Re: Initial Stormwater & Wetlands Peer Review  
Comprehensive Permit Application  
Mallard Lane, Bolton MA

The Horsley Witten Group (HW) is pleased to provide the Bolton Zoning Board of Appeals (ZBA) with this letter report summarizing our initial technical peer review of the residential development proposed along South Bolton Road between Wheeler Road and Spectacle Hill Road in Bolton, MA. Ducharme & Dillis Civil Design Group, Inc. have prepared the Comprehensive Permit Plan set and Stormwater Report on behalf of James Morin (Owner). The proposed development includes eleven detached age-restricted single family residential dwellings with one common driveway. The 4.70-acre undeveloped parcel includes an off-site wetland area as shown on the project plans. HW understands through conversations with the Bolton Conservation Agent that a Determination of Applicability was issued by the Bolton Conservation Commission indicating the need for the Applicant to file a Notice of Intent (NOI) with the Conservation Commission for work proposed within the 100-foot buffer to the wetland area.

Image 2. Screenshot of MassGIS data indicating that the isolated wetland is identified as a Potential Vernal Pool (PVP).

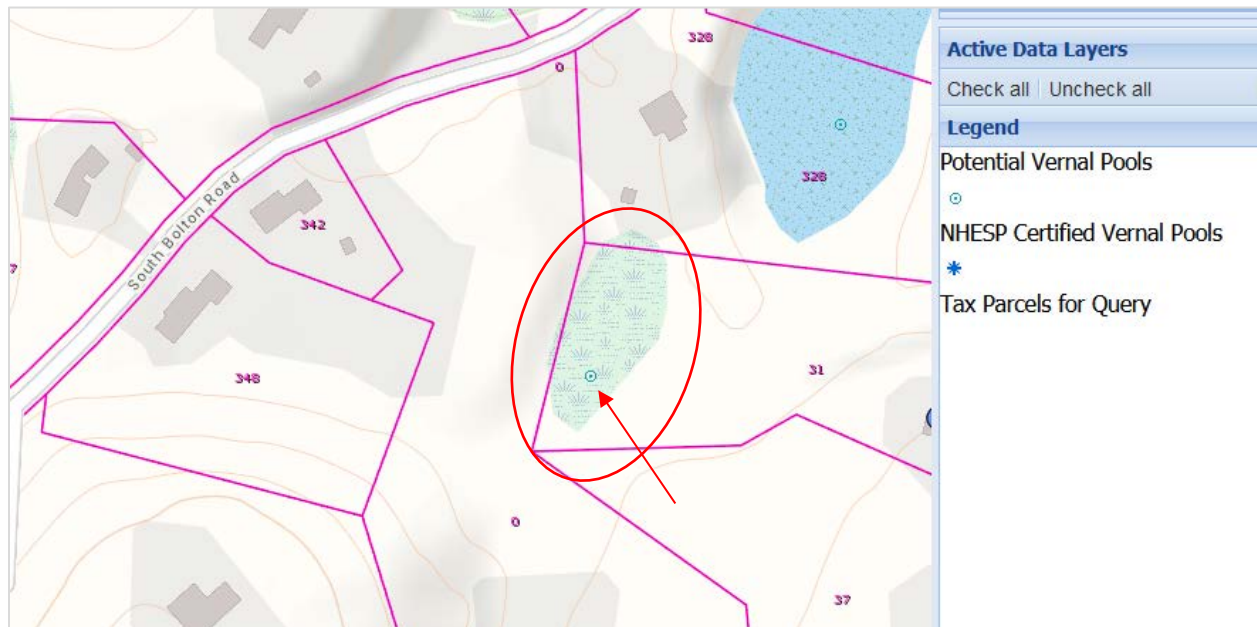
HW notes that the isolated wetland area has been identified by the Massachusetts Natural Heritage and Endangered Species Program (NHESP) as a Potential Vernal Pool (PVP #2912) (Image 2).

In speaking with the Conservation Agent, we understand that a local school group has collected sufficient data to certify this wetland area as a state-recognized Certified Vernal Pool. However, in accordance with Section 3.07(3)(e), the Conservation Commission may recognize and regulate vernal pool habitat regardless of its NHESP certification status.

Based upon this, and the information from the Conservation Agent, it is HW's professional opinion that this wetland area meets the presumption under the local regulations as a vernal pool. The Grading & Drainage Plan indicates that portions of the proposed access road, portions of three of the proposed structures, installation of a sewer line, site grading, and construction of a structural retaining wall in closest proximity to the wetland area (i.e., just outside of the 25-foot wetland buffer as shown). Additional work may occur within jurisdiction of the other wetland area (Photo 6). Finally, the project site entrance will result in grading within the buffer zone to the wetland across South Bolton Road to the north.

3. As the performance standards for work within 100-feet of a vernal pool are more stringent and include a limitation on the removal of trees within 100 feet of a vernal pool, we recommend that the Applicant at a minimum file an ANRAD with the Conservation Commission to confirm the wetland boundary as recommended above, and quantify the removal of trees in this area as well as the amount of disturbance within vernal pool habitat, such that the Town may better understand the environmental implications of the extent of work proposed within the 100-foot buffer. Similar calculations should be presented for the project work within the buffer zone to the other wetland areas.
